Response to Comments of Parties

Ameren Missouri – 2011 Integrated Resource Plan

Figure 2.4 Cumulative Peak Demand Savings

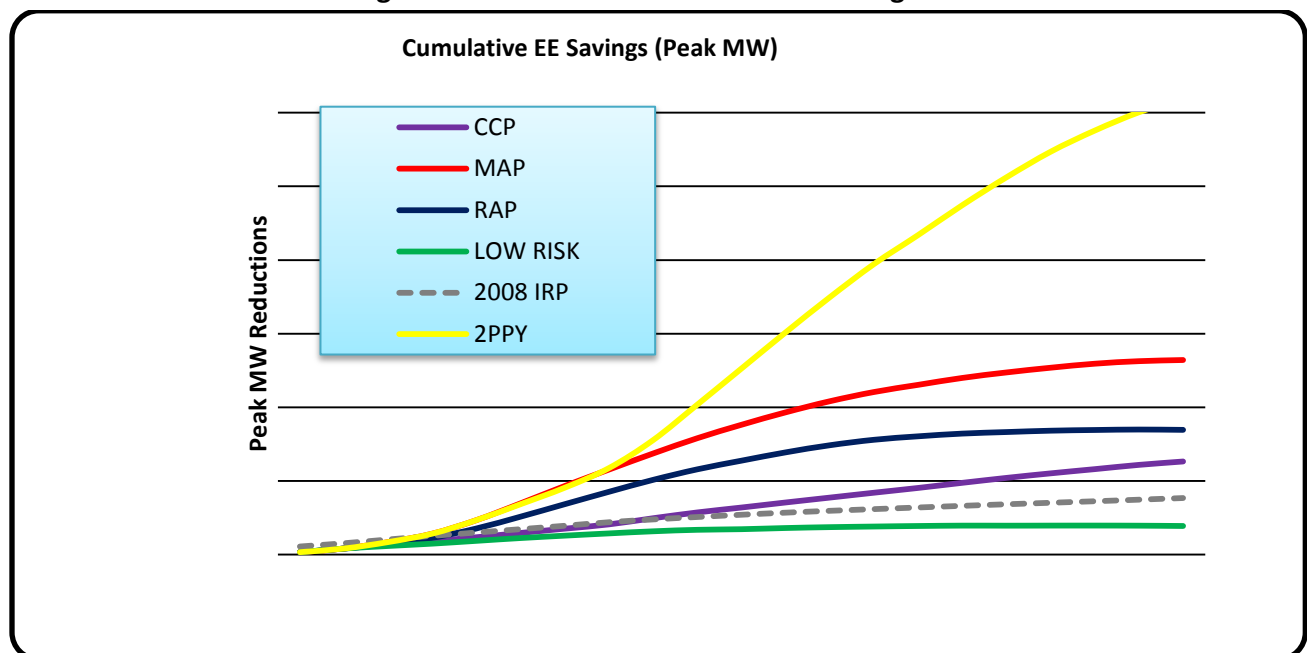
Issue Summary: OPC asserts that Ameren Missouri did not develop alternative resource plans that capture the full range of demand-side resources, citing 22.010(2)(A), which requires evaluation of demand-side resources on an equivalent basis with supply-side resources, and 22.060(3), which requires the development of a range of alternative resources plans designed to achieve one or more planning objectives. OPC contends that Ameren Missouri did not consider a sufficient range of demand-side resource portfolios and that the lack of more portfolios to analyze restricts minimization of PVRR. OPC further asserts that the RAP portfolio underestimates the amount of energy savings that could be achieved by assuming what OPC considers to be low financial incentives to participating customers and low awareness of the efficiency programs, two parameters over which it states the Company has control. Finally, OPC contends that Ameren Missouri has not complied with the Commission’s order in Ameren Missouri’s 2008 IRP (Case EO-2007-0409) which required the Company to “model an even more aggressive approach to encourage participation in demand-side management programs in its next filing.”

Ameren Missouri’s Position and Evidence: Ameren Missouri has evaluated a broad range of DSM programs and portfolios and has evaluated inclusion of DSM resources on an equivalent basis with supply-side resources. OPC’s assertions disregard the fact that the Company evaluated five different DSM portfolios – MAP, RAP, Low Risk, CCP, and 2% load reduction, that all but the Low Risk portfolio result in greater demand and/or energy savings than that included in Ameren Missouri’s 2008 IRP, and that a comparison of the RAP and CCP portfolios provided a rigorous test of different mixes of energy efficiency and demand response resources.

Figure 2.2, presented previously in this report, shows that energy savings for the RAP portfolio are roughly equivalent to those included in Ameren Missouri's 2008 IRP, while energy savings for the MAP and 2% annual load reduction portfolios are significantly higher. Figure 2.4 shows that demand savings are greater for the RAP, MAP, CCP and 2% annual load reduction portfolios than that for the 2008 IRP portfolio.

Conclusion: Ameren Missouri has evaluated a broad range of portfolios, including several that are more aggressive than that included in the Company's 2008 IRP filing. Ameren Missouri has appropriately limited the inclusion of DSM programs to those needed to meet load and reserve requirements and evaluated the trade-offs between demand response and energy efficiency by evaluating portfolios constructed with different levels of each. In doing so, Ameren Missouri has treated demand-side resources on an equivalent basis with supply-side resources and has developed alternative resource plans in compliance with the IRP rules.

Figure 3.3 Projected Meramec Capex from Burns and McDonnell Condition Assessment
Figure 21 – Projected CAPEX through 2041 (Then-Year \$'s)

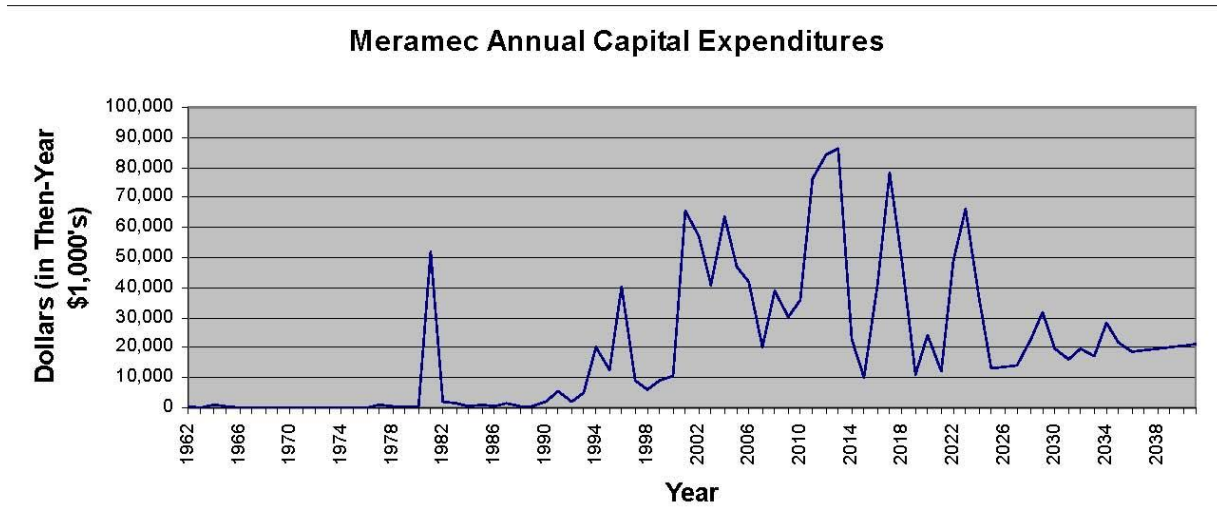
NRDC asserts that Ameren Missouri has inappropriately assumed that the capital and operating costs for the Meramec plant will decrease rather than increase as the units age. As shown in Figure 3.3 below, the forecast assumptions for capital costs include specific major projects during the 2011-2025 timeframe, as detailed in the Burns and McDonnell report, and an increasing level of baseline capital expenditures thereafter.

NRDC questions the future capital and O&M budgets developed by Burns and McDonnell based on comparisons to recent history. This kind of comparison is not valid because Ameren Missouri has made significant investments in major component replacement and refurbishment in recent years that will not have to be made again for the remaining life of the plant. For example, the unit 4 turbine was replaced in 2005 and would not have to be replaced again even in the 2041 retirement scenario. In the Meramec Condition Assessment Report, Burns and McDonnell included a comparison of historical capital and O&M expenditures to forecasts for the scenarios evaluated. They explicitly address the comparison in the following narrative from page 115 of the report:

Figure 10.1 Lost Revenue Impact on Earnings by Rate Case Frequency

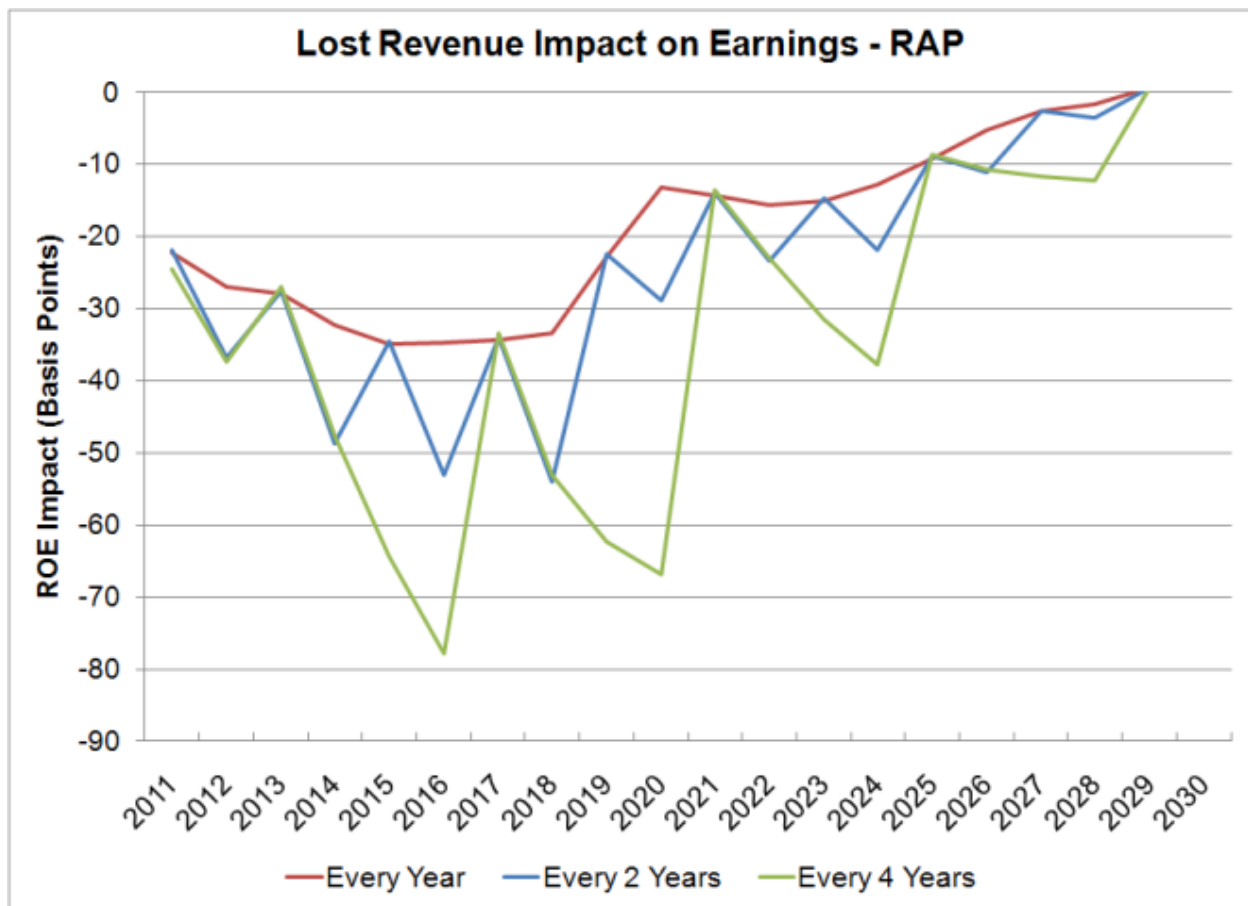
Ameren Missouri's Position and Evidence: Ameren Missouri has documented the subjective probabilities for uncertain factors as required by 22.070(1), has performed the preliminary sensitivity analysis required by 22.070(2), and has documented the values and probabilities for uncertain factors as ordered by the Commission in EO-2007-0409. A discussion of the uncertain factor ranges is presented in Chapter 9 of Ameren Missouri's IRP filing, beginning on page 15. NRDC's connection of requirements for evaluation of uncertain factors to the Company's analysis of lost revenue is nonsensical.

Ameren Missouri has clearly established through explicit analysis the harmful financial effects of lost revenues and has set an appropriate range for allowed ROE for the planning horizon. NRDC's assertion that the Company has not proven that lost revenues would result in ROE deterioration completely ignores the results of the Company's explicit analysis of this issue presented in Chapter 10 of the IRP filing and supported by detailed workpapers. Figure 10.1 below shows the impact on ROE due to lost revenues under a plan that includes the RAP DSM portfolio for several different assumptions of rate case frequency.

As can be seen, the impacts on ROE can be significant even with annual rate cases. This same chart was presented in the Company's IRP filing in both Chapter 1 (Figure 1.10, page 17)) and in Chapter 10 (Figure
